VIRGINIA ELECTRIC AND POWER COMPANY
RICHMOND, VIRGINIA 23261

Serial No. 01-327A
NL&OS/ETS R0
Docket Nos. 50-338/-339
License Nos. NPF-4/-7

VIRGINIA ELECTRIC AND POWER COMPANY
NORTH ANNA POWER STATION UNITS 1 AND 2
INSERVICE TESTING PROGRAM FOR PUMP AND VALVES
THIRD TEN YEAR INTERVAL UPDATE
REQUEST FOR ADDITIONAL INFORMATION

**North Anna Unit 1
Inservice Testing Program
Revised Relief Requests**

OUTSIDE RECIRCULATION SPRAY PUMP 1-RS-P-2A

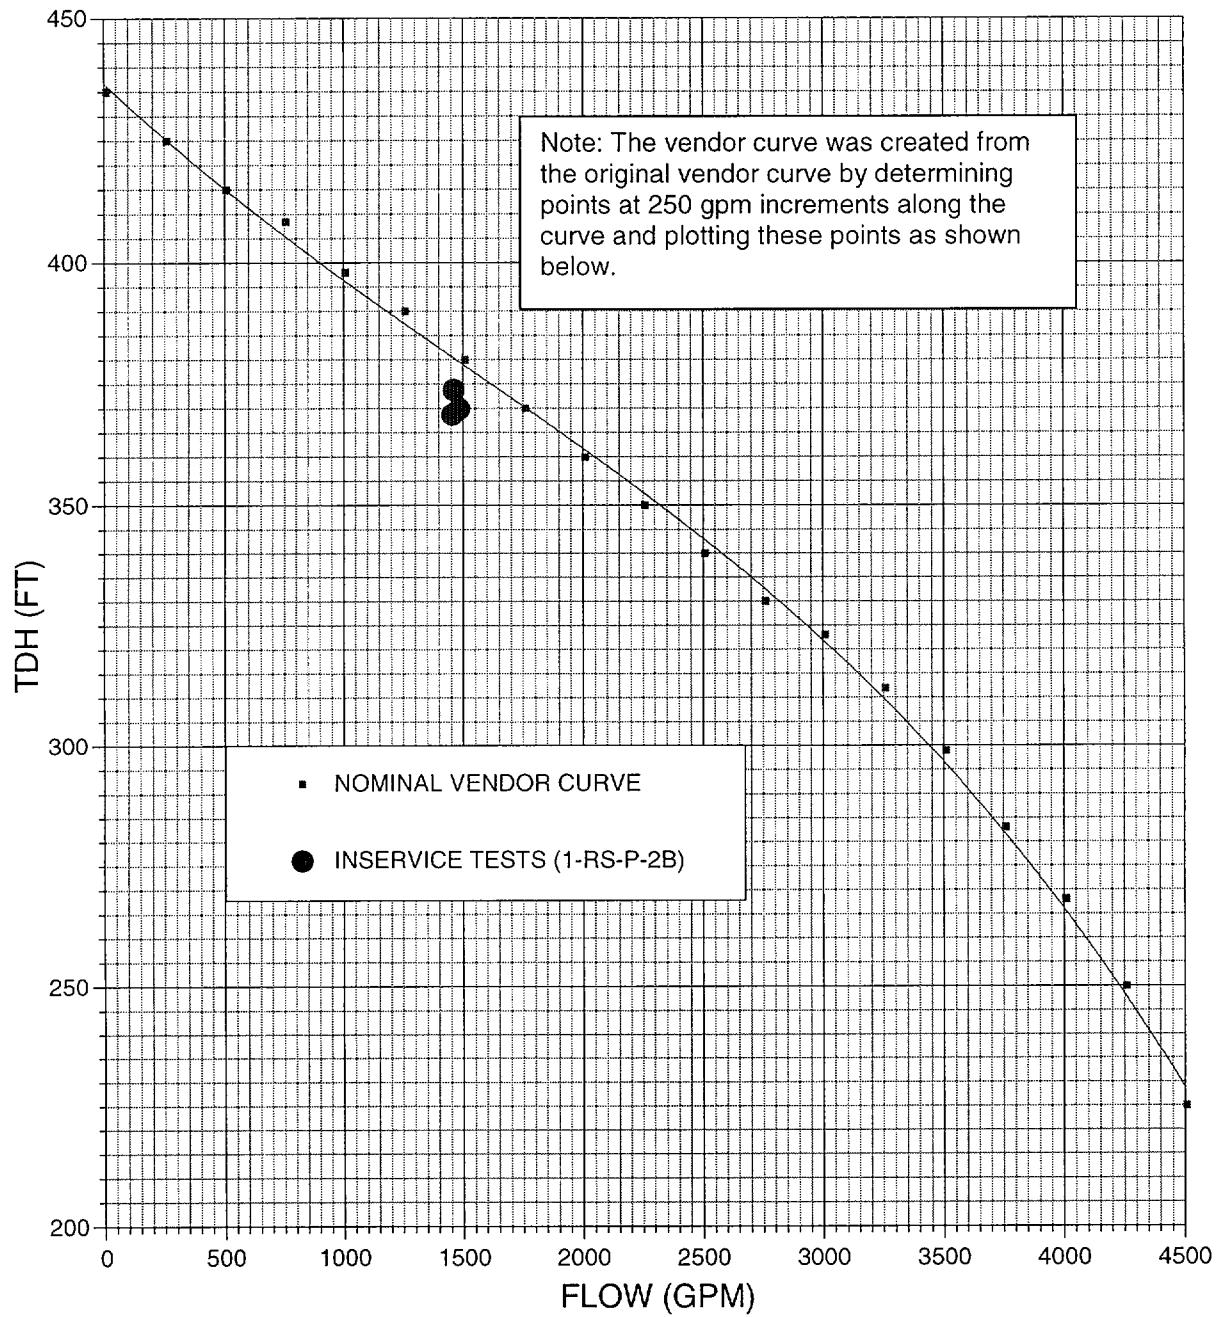
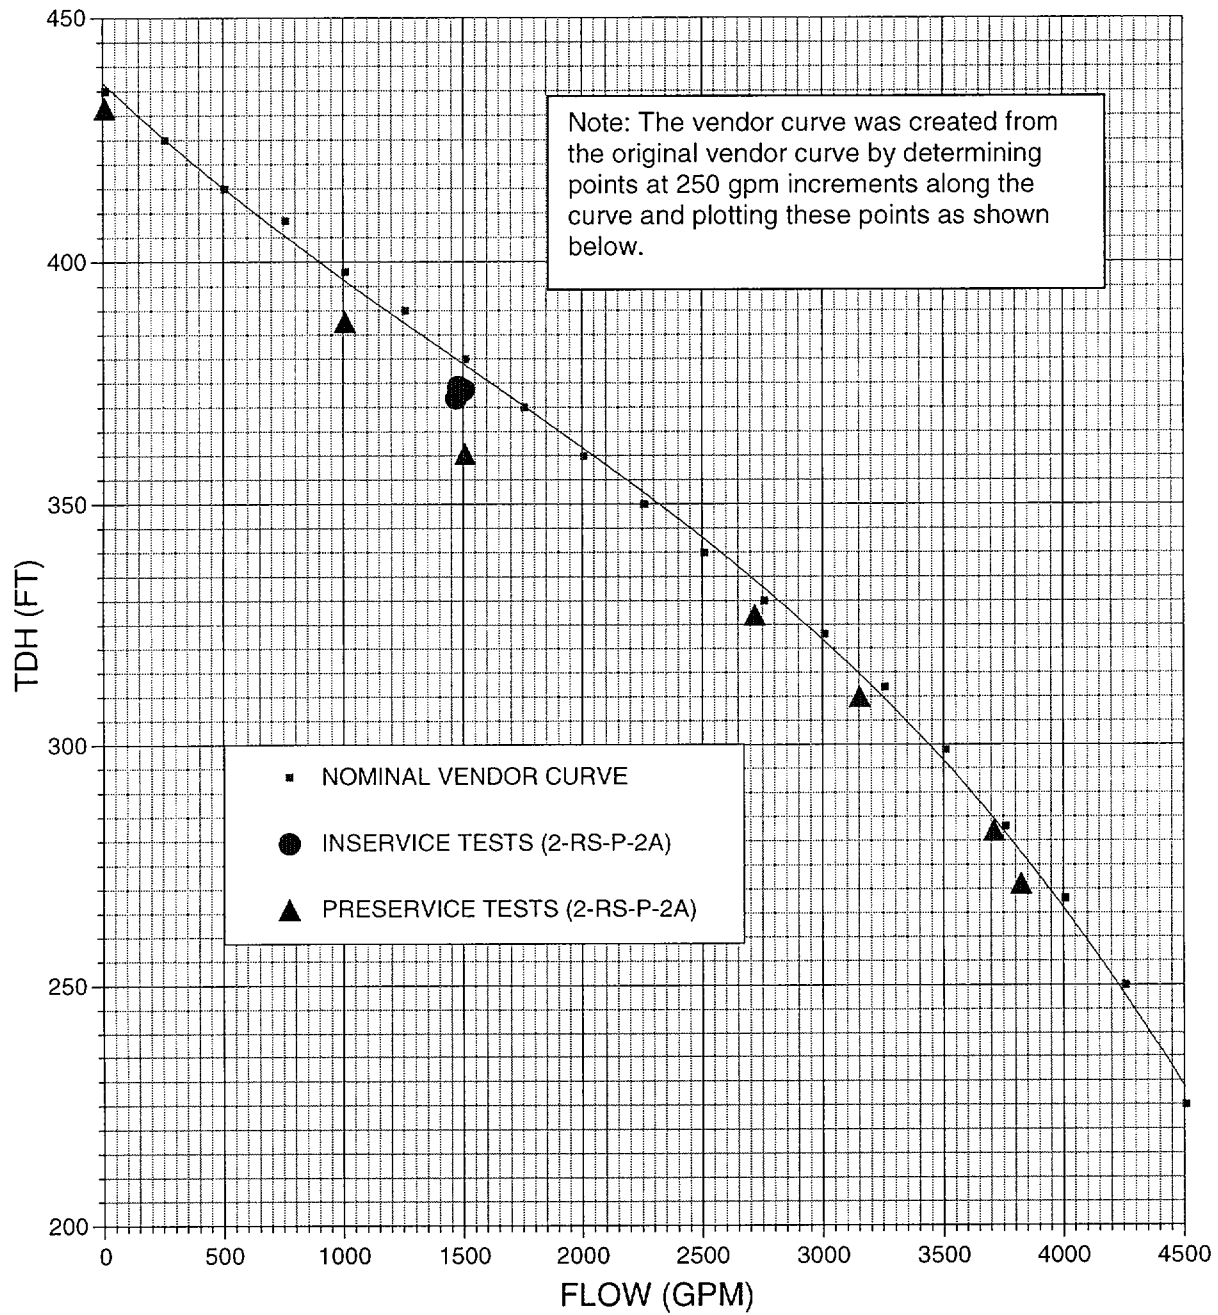
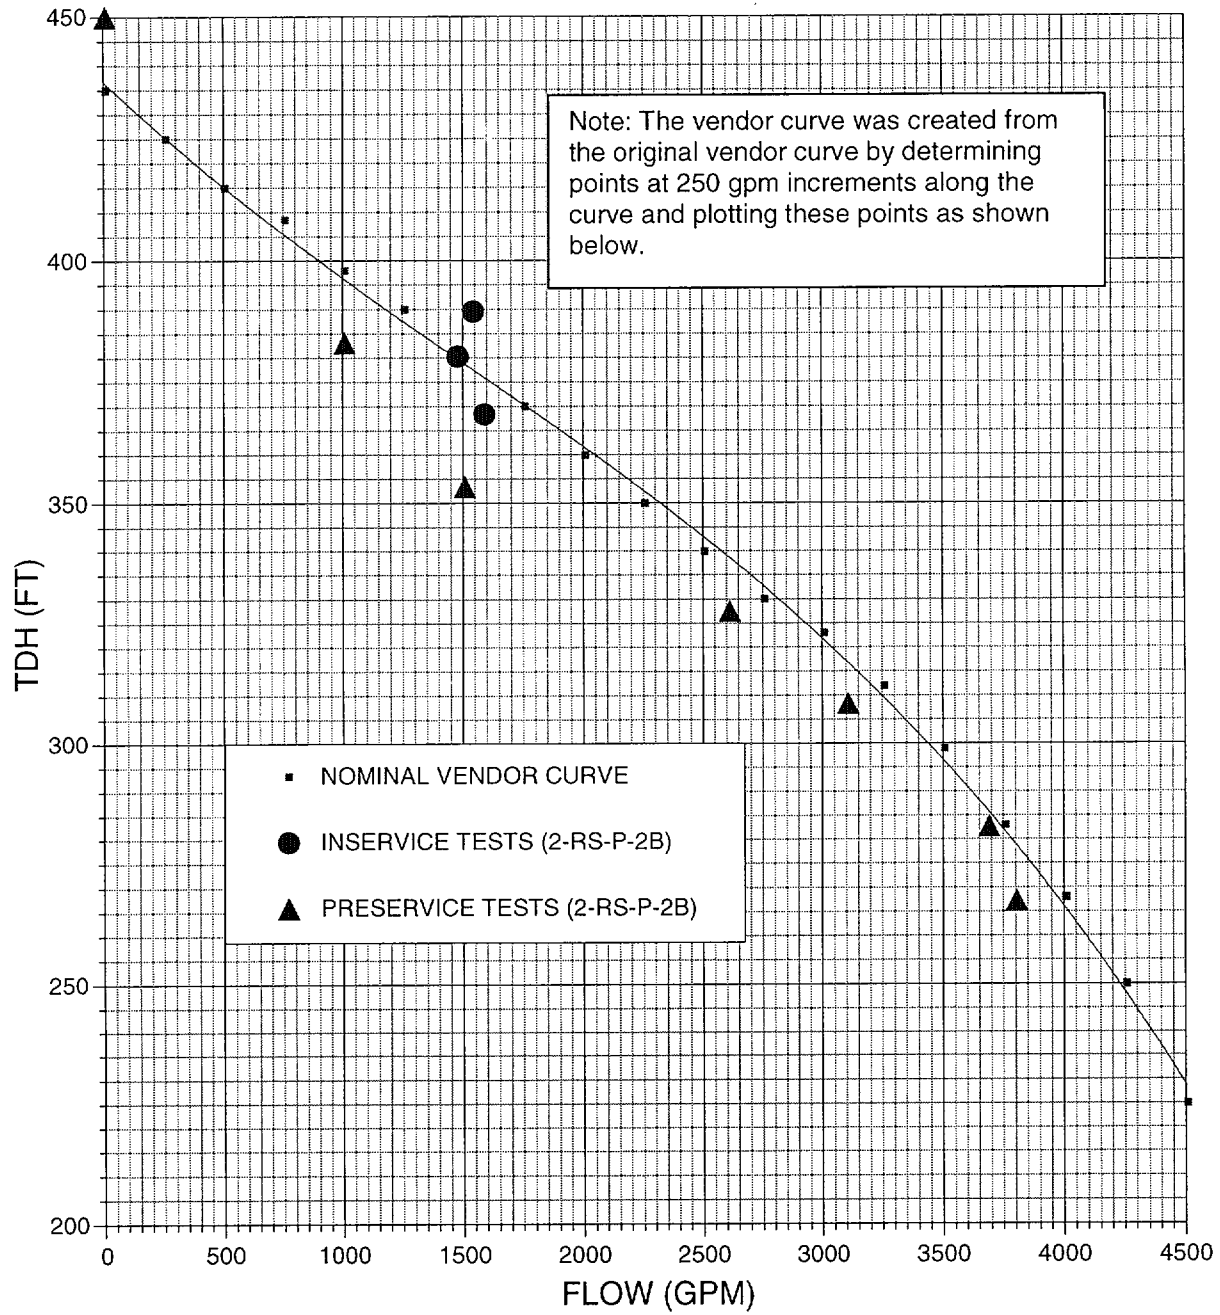
RELIEF REQUEST NO.	DESCRIPTION OF CHANGE
	The four figures following the document are provided to aid the NRC in evaluating the bases in P-6. These figures show the nominal vendor pump curve and IST data points for pumps 1-RS-P-2A and B, and 2-RS-P-2A and B. In addition, preservice data points are given for the Unit 2 pumps. There were no preservice tests performed for the Unit 1 pumps.
P-7	For auxiliary service water pump 1-SW-P-4, the need for and consequently the request for relief from the discharge pressure instrument accuracy requirement was eliminated. Based on guidance from ASME OM Interpretation 95-6, certain terms in the instrument loop accuracy calculation can be excluded, resulting in a calculated value for loop accuracy that is within $\pm 2\%$. In the alternate testing section, 10 CFR 50.55a(a)(3)(i) was added as a reference.

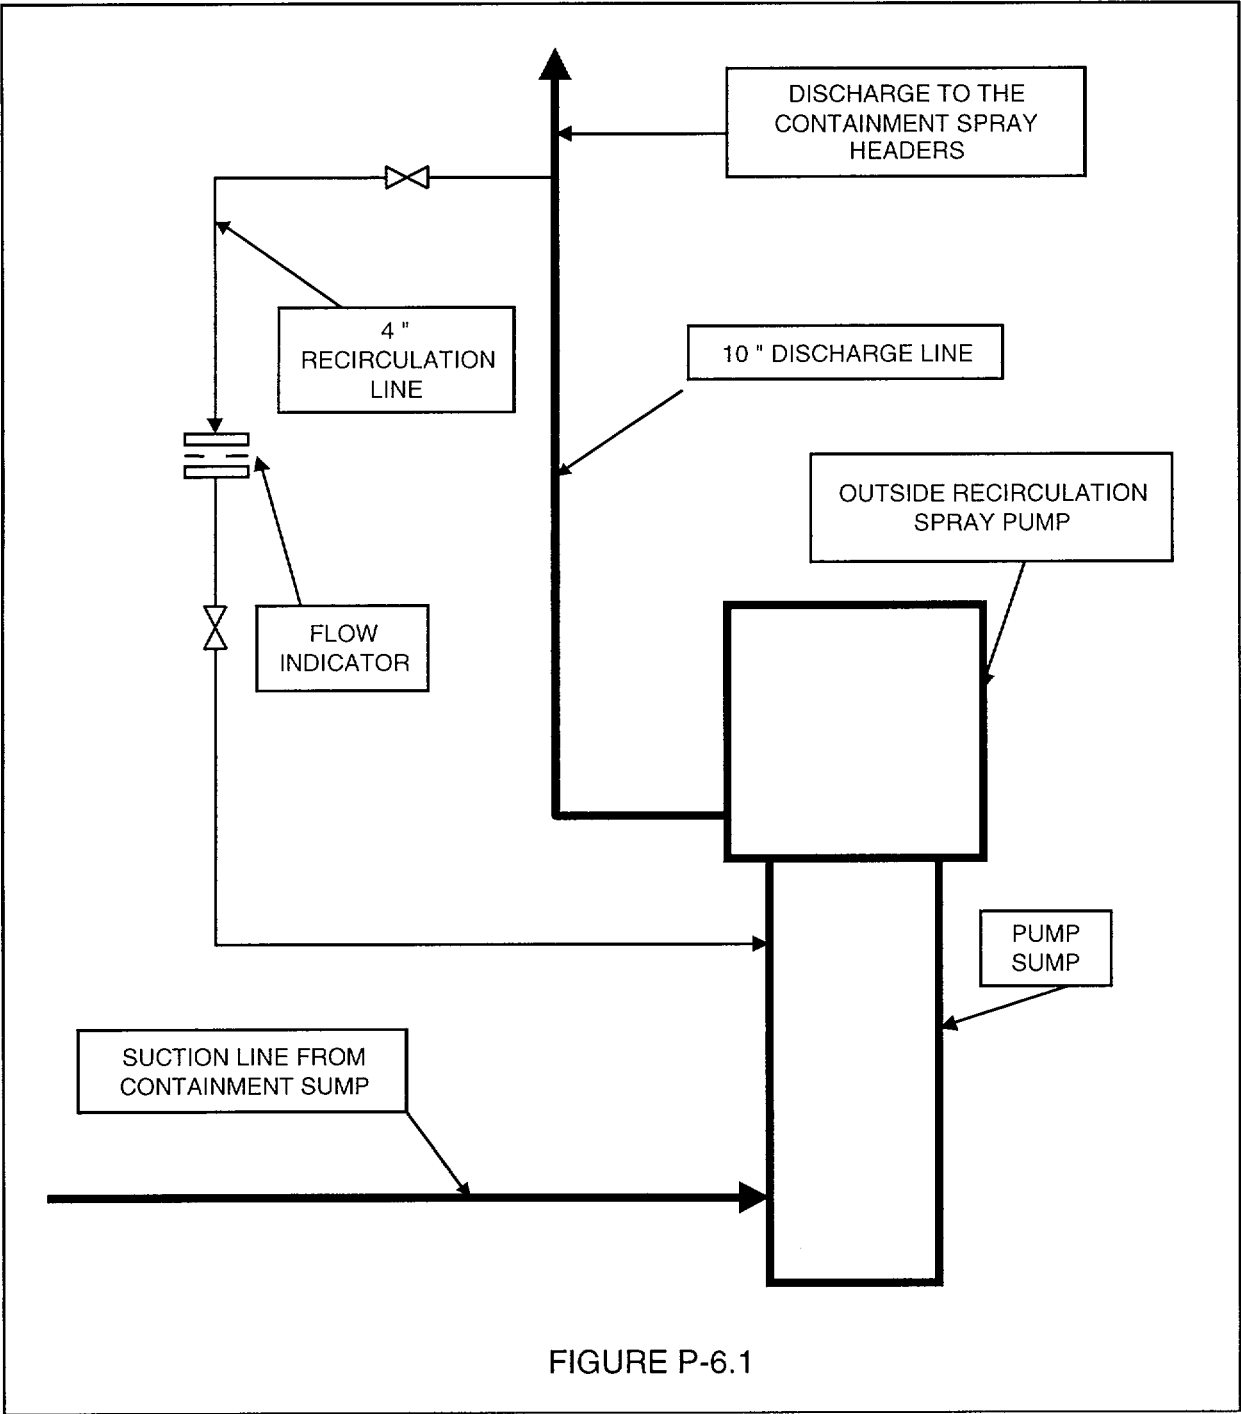
The test loop for the outside recirculation pumps consists of a 10" pump discharge line feeding into a 4" recirculation line which feeds back to the pump sump. Refer to Figure P-6.1. With this test loop, pump design flow cannot be established. Also, the discharge piping was not designed to be temporarily reconfigured so that pump design flow could be achieved.

As an alternative to flow testing at the design flow rate, the test loop shown in Figure P-6.1 will be used. Reference flows are typically established with this test loop in the range of 1450 to 1500 gpm, whereas the pump design flow is 3640 gpm. The low reference flows result from restrictions due to the small 4" recirculation line and the limited volume of water in the test loop. The limited water volume results in a rapid temperature rise in the test loop due to heat loads added by the running pump. This temperature rise affects repeatability of the measured hydraulic parameters. Therefore, care must be taken to ensure that the pump run time is limited and that the flow rate is maintained within an optimal range.

FIGURE P-6.2

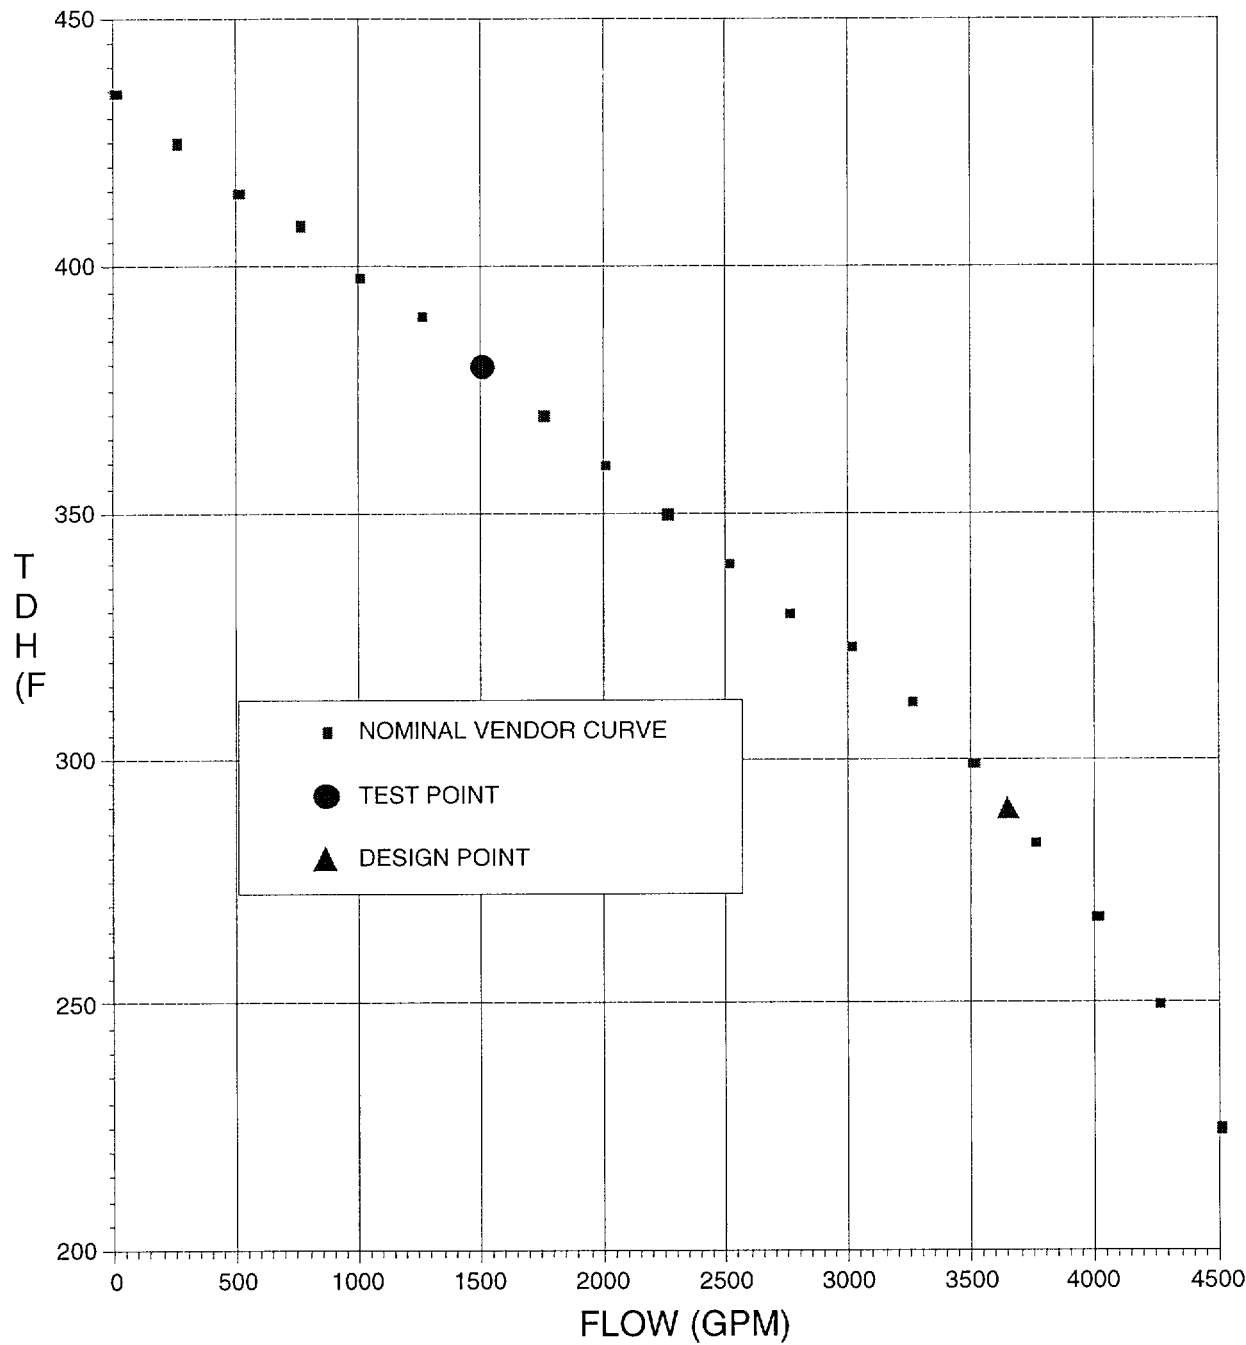
In the 1450 to 1500 gpm range of the head curve for these pumps, the head curve is not flat, but well sloped. Refer to Figure P-6.2. Therefore, as performance degrades due to internal recirculation caused by increasing internal pump clearances, the differential pressure will measurably decrease for a given reference flow rate. As discussed above, testing the outside recirculation spray pumps over the full range of the pump curve and measuring at least five points along the curve is impractical.

As an alternative to testing within 20% of the design flow, the reference values will be established at approximately 40% of the design flow. It is our understanding that testing at design flow is important for pumps with characteristic head-flow curves that are flat or gently sloping in the low flow region (little change in developed head with increasing flow). In the low flow region, increasing internal flows, usually due to wear, are difficult if not impossible to detect. Pumps with the "flat" curves at low flows should be tested at near design conditions to determine if increasing internal recirculation flows have degraded pump performance to the point where design requirements cannot be met. This situation does not apply to the outside recirculation pumps if they are tested at 40% of design flow. Testing at the reference flows will detect pump degradation because the pump curve is well sloped at the point of testing. Refer to Figure P-6.2.
